TABLE B.3 - ATLANTIS Starboard Squirt Boom and Aft CTD Winch
Note: Some of the figures below are estimates for Appendix B illustration only.

GEOTRACES LHS - KNORR
Note: Some of the figures below are estimates and are provided for Appendix B illustration purposes only.

R/V ATLANTIS
(AGOR 25)

WHOI HYDROBOOM

Figure 8: Port Foundation Modifications

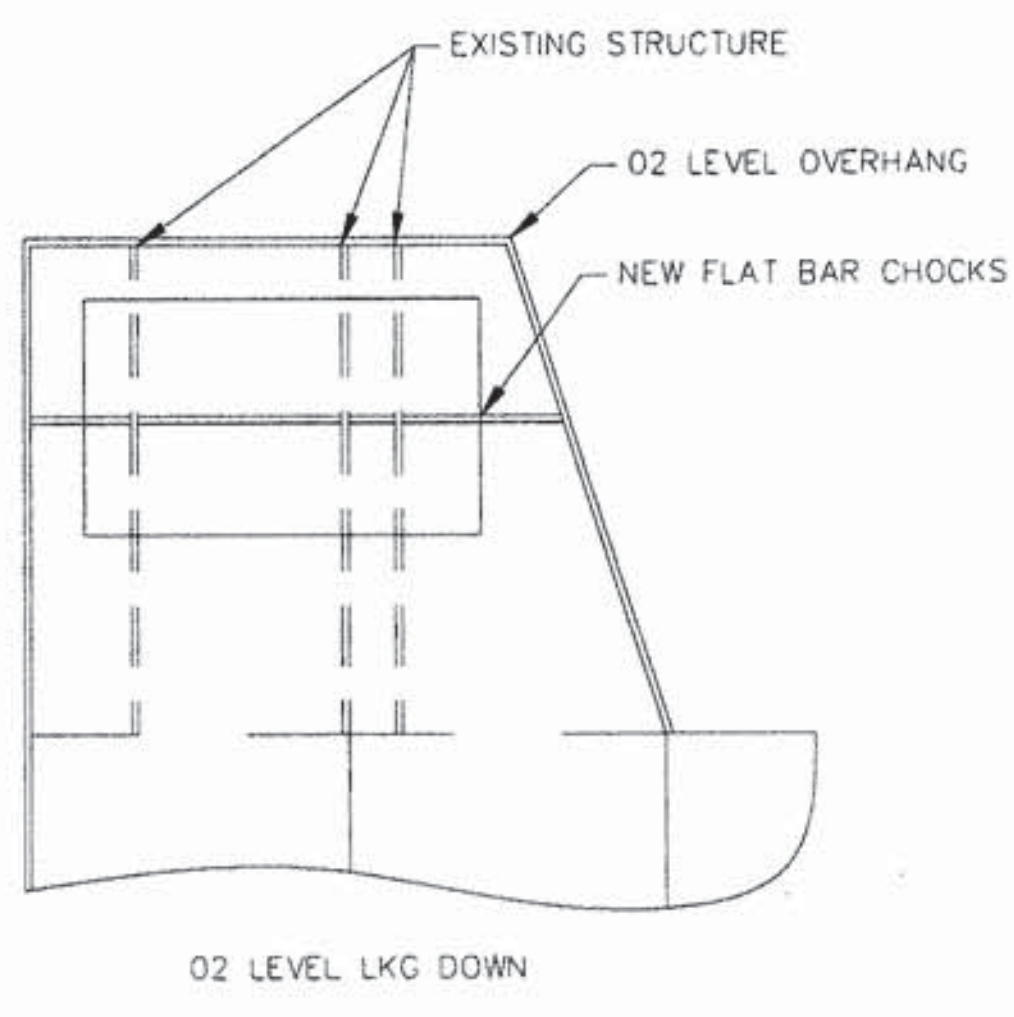
The existing transverse structure supporting the portside foundation includes two 8" x 1/2" flat bars, and a 5" x 3" x 1/4" angle. The stress in each of these members exceeds the allowable bending stress; therefore, a new longitudinal flat bar chock should be installed to break up the span of the transverse members. This will help distribute the load to the large transverse girders (see Figure 8).
